# UNITED STATES PATENT AND TRADEMARK OFFICE

APPLICATION NO.	FILING DATE	FIRST NAMED INVENTOR	ATTORNEY DOCKET NO.	CONFIRMATION NO	
09/516,655	03/01/2000	Thomas C. Thompson		3209	
75	90 02/18/2004		EXAMINER		
Thomas C Thompson 92-543 Kokole PLace			GARCIA, ERNESTO		
Makakilo, HI			ART UNIT PAPER NUMBE		
·			3679		
			DATE MAILED: 02/18/2004

#### **DETAILED ACTION**

Attachments: three marked-up copies of Way, Sr., 5,813,173 showing Figures 3, 4 and 6.

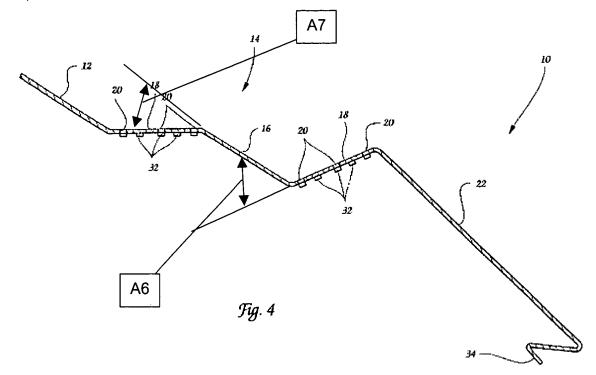
Claims 1 and 3-7 are rejected under 35 U.S.C. 102(b) as being anticipated by Way, Sr., 5,813,173 (see marked-up attachments).

Regarding claim 1, Way, Sr. discloses in Figures 3, 4 and 6 a unitary connector comprising a base web 18 (the right one in Fig. 4), offset, angled, blocking webs A2 (Fig. 3), and an offset web 16. The blocking webs A2 each have a generally right angled bend A3 forming a rafter tab A4 (Fig. 6). The base web 18 and each of the blocking webs A2 is connected by the offset web 16. The offset web 16 has a first acute angled bend A6 attached to the base web 18 and a second, unequal, acute angled bend A7 attached to the blocking webs A2.

Regarding claim 3, the offset web **16** is connected to the base web **18** by the first acute angled bend **A6** at an acute angle.

Regarding claim 4, the offset web **16** is connected to the blocking webs **A2** by the second, unequal, acute angled bend **A7** at an acute angle.

Regarding claim 5, the first acute angled bend **A6** and the second, unequal, acute angled bend **A7** are attached to opposite ends of the offset web **16**, having generally unequal acute bends in opposite directions, thereby offsetting the blocking webs **A2** at an acute angle from the base web **18** and avoiding frieze boards or blockings on a house.

Regarding claim 6, the first acute angled bend **A6**, the second, unequal, acute angled bend **A7**, and the offset web **16** forming the base web **18** and the blocking webs **A2** unparallel to each other. Thereby forming a buttress between a roof rafter and the wall with underlying structural members, thereby preventing the exterior wall from detaching from the roof.

Regarding claim 7, the blocking webs **A2** divide the blocking webs **A2** into generally equal left and right blocking webs **A2**.
